SUBSURFACE SEWAGE TREATMENT SYSTEM (SSTS) COMPLIANCE REPORT

Inspection Address: 7740 Field Ridge Rd, Grant, MN 55110

Compliance Inspection Form
Existing Subsurface Sewage Treatment Systems (SSTS)

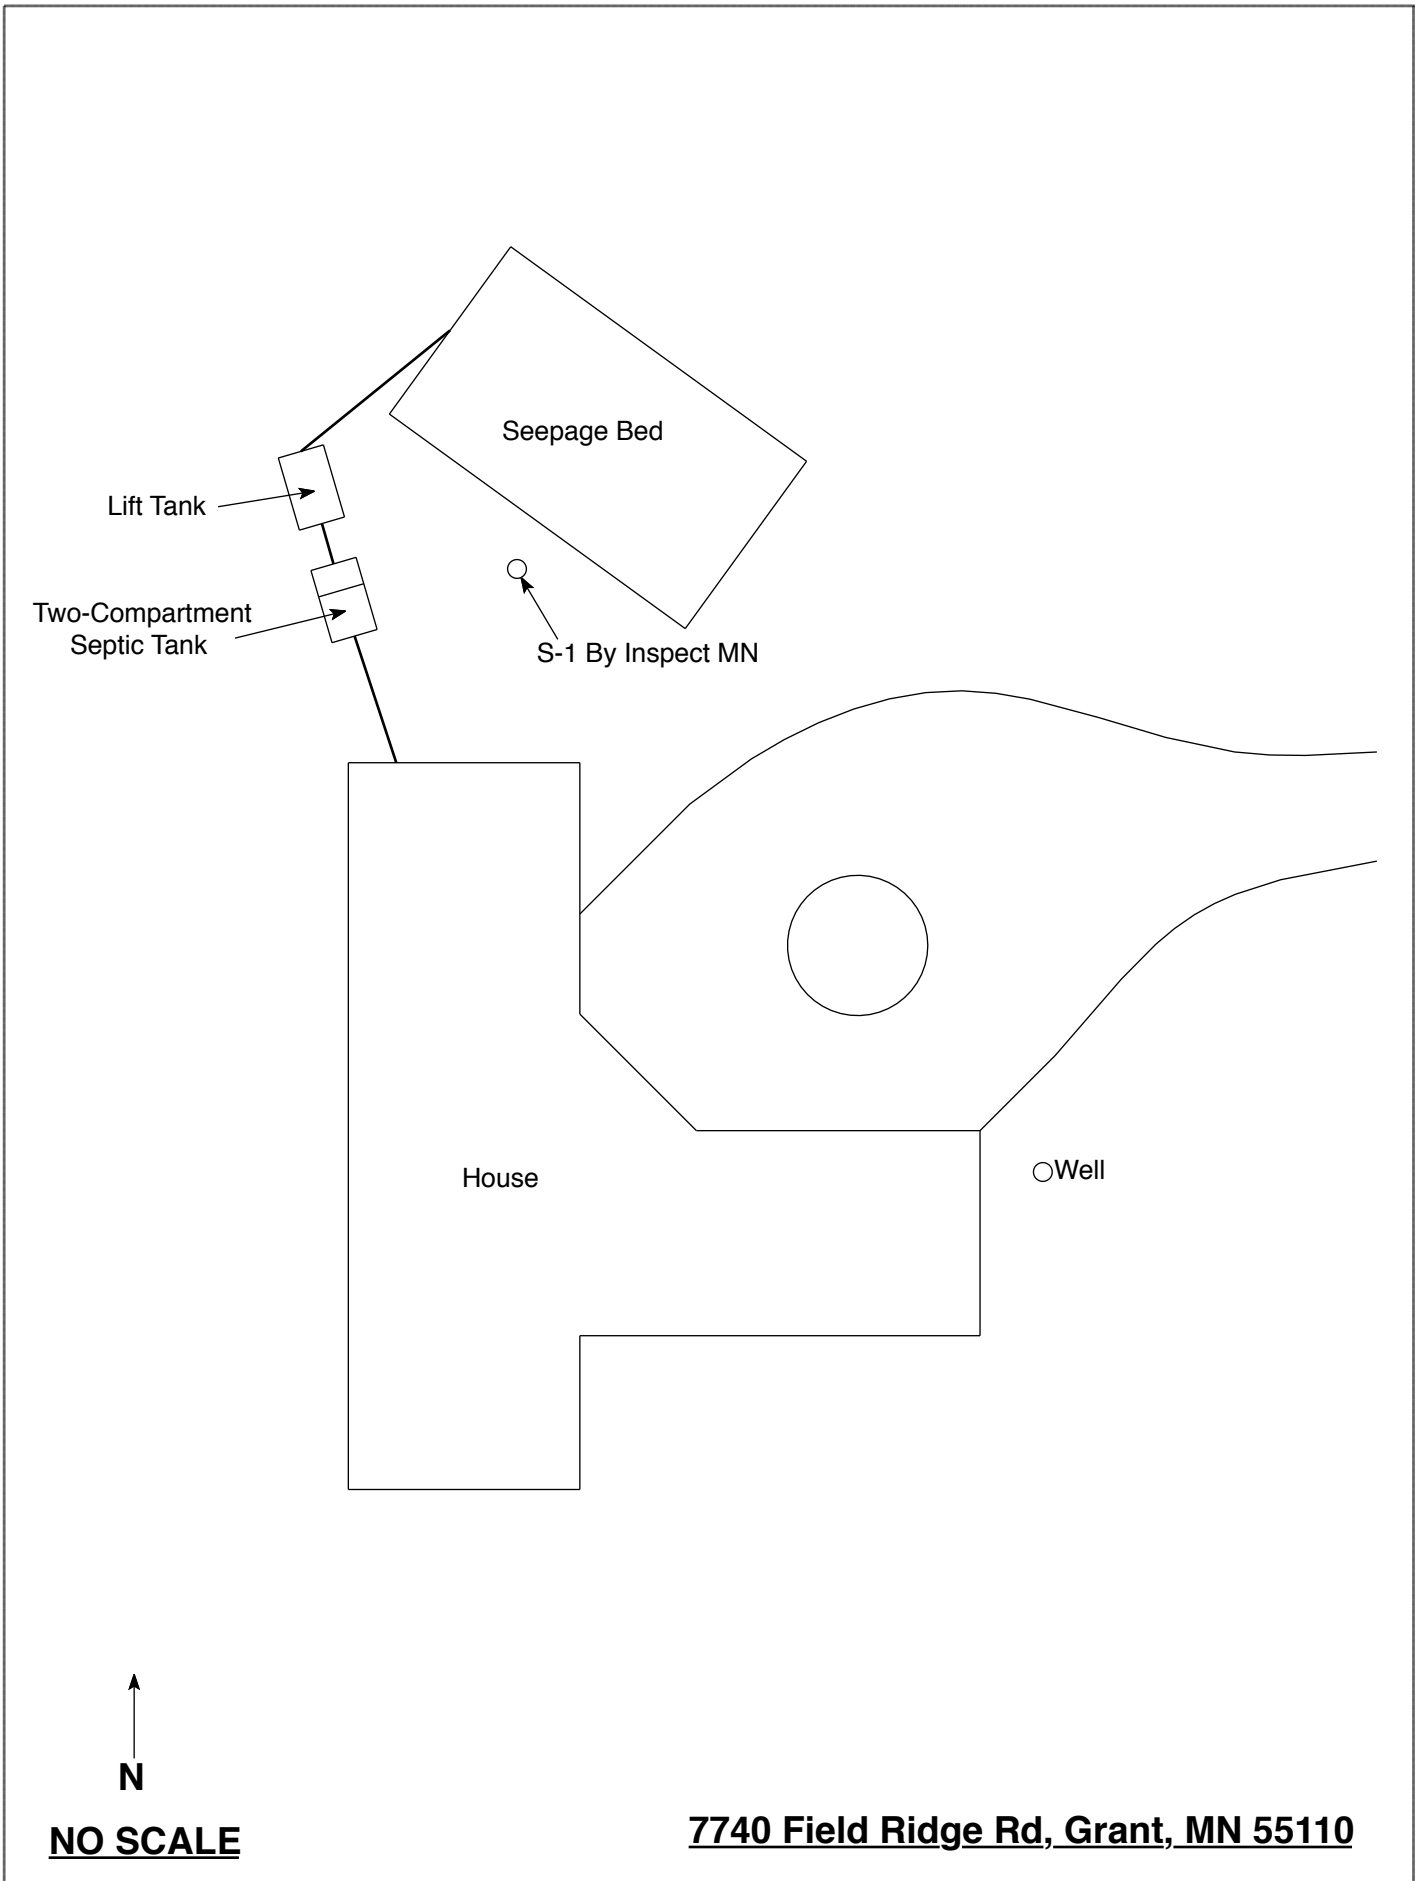
My inspection indicates that this system is presently “non-compliant” in accordance with MPCA rules 7080.1500 Subp.4(B)(D) because of the lack of the required three foot separation between the bottom of the drainfield and seasonally saturated soils.
